APPLICATION NO.	FILING DATE	FIRST NAMED INVENTOR	ATTORNEY DOCKET NO.	CONFIRMATION NO.
10/737,124	12/17/2003	Young-Doug Kim	8947-000074/US	5936
30593 7590 09/22/2008 HARNESS, DICKEY & PIERCE, P.L.C. P.O. BOX 8910 RESTON, VA 20195				
EXAMINER				
DANG, KHANH				
ART UNIT		PAPER NUMBER		
2111				
MAIL DATE		DELIVERY MODE		
09/22/2008		PAPER

Office Action Summary

DETAILED ACTION

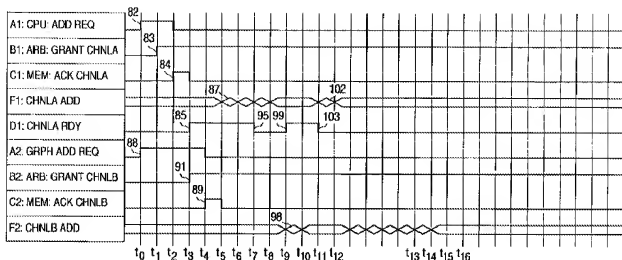
particular, in Kenny, a master module initializes bus access by asserting address and bus request signals on the bus 11. The arbiter 4 and the slave module detect the address and request signals asserted by the master module. The arbiter 4 then identifies the master module making the request, determines the master module's priority, and grants a virtual channel. The virtual channel granted can be arbitrarily selected by an allocation procedure. Specifically, Kenny discloses that "concurrent ownership of the data bus by multiple master/slave pairs advantageously enhances bus accessibility over conventional split-transaction bus protocols since the transactional overhead associated with bus re-acquisition protocols between a master/slave pair is eliminated. Since each channel, hence each master/slave pair, has its own unique channel active signal, data transfer between the master/slave pair commences immediately upon the arbiter asserting the appropriate "channel active" signal." Kenny further discloses that "FIG. 9 is a timing diagram summarizing concurrent transactions of three virtual channels of the present invention." In addition, Kenny discloses that "[a]ll concurrent virtual channel owners wait for an access grant by arbiter 4 to data bus 2. Access to data bus 3 to a particular virtual channel occurs when arbiter 4 asserts the virtual channel's active signal (e.g., CHNLA ACTIVE). Note that in Fig. 9, because the priority of each requesting master (CPU, PCI Controller, Graphics Controller) is not pre-assigned, the arbiter 4 must resolve the priority between requesting masters, and grants virtual channels A, B, C to each requesting master based on priority of each requesting master, by asserting signal GNT CHLNA, signal GNTCHLNB, and signal GNTCHLNC, at times t1, t3, and t5. Fig. 9 is reproduced below:

Although Kenny clearly disclose that pseudo-grant signals are generated to all the requesting masters. Kenny, as discussed above regarding Fig. 9, does not particularly disclose that the pseudo-grant signals begin at the same time, as claimed in at least Applicants' claim 1, and shown in Fig. 6, which is reproduced below:

Thus, it would have been obvious to one of ordinary skill in the art at the time the invention was made to generate pseudo-grant signals GNT CHLNA, GNTCHLNB, and GNTCHLNC to all requesting masters beginning at the same time, because by using a fixed virtual channel with a pre-assigned priority for each of the requesting master, the arbiter 4 does not have to arbitrate between masters resulting in generating/providing pseudo-grant signals to all requesting masters at different starting time. Since pseudo-grant signals GNT CHLNA, GNTCHLNB, and GNTCHLNC to all requesting masters begin at the same time, it is clear that arbitration latency can be further reduced, and as a result, the overall performance of the entire system of Kenny is improved.

Fig. 6

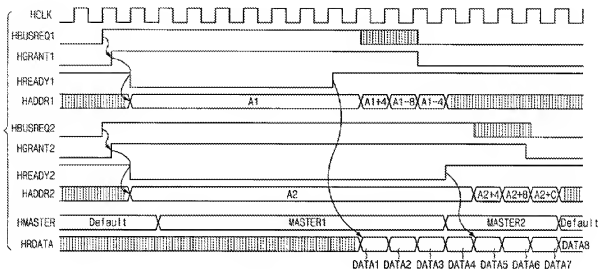
Note that in Fig. 6 above, the pseudo-grant signals HGRANT1 and HGRANT2 begin at the same time.

Fig. 6

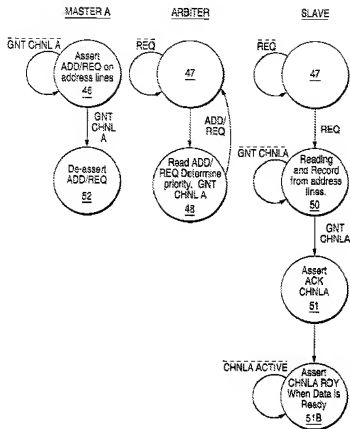
Appellants have also argued that "[r]eferring to FIG. 6 of Kenny, upon detecting the ADD/REQ signal from the master module A, the arbiter 4 asserts grant channel A signal GNT CHNLA on address bus 3 to assign a virtual channel to master module A. Kenny at 7:34-7:37. After transmitting the virtual grant channel A signal GNT CHNLA, arbiter 4 returns to its initial state 47 to wait for the next ADD/REQ signal.

Id. at 41-42. But, the next ADD/REQ signal received by the arbiter 4 is independent or- not in response to - the grant channel A signal GNT CHNLA signal from the arbiter 4. Thus, contrary to claim 1, the arbiter 4 issues a virtual channel grant (grant channel A signal) GNT CHNLA in response to a ADD/REQ signal from a master module 4, but does not receive 'transaction information from all requesting master units in response to the pseudo-grant signals.'"

Contrary to Appellants' argument, it is clear from Kenny, particularly Fig. 6, which is reproduced below for ease of reference and convenience, and discussion above that the next ADD/REQ is not independent. As a matter of fact, the next ADD/REQ would not be sent to the master if the GNT without reception of the GNT signal. In other words, ADD/REG (transaction information) from requesting masters is sent to the arbiter in response to the pseudo-grant signals.
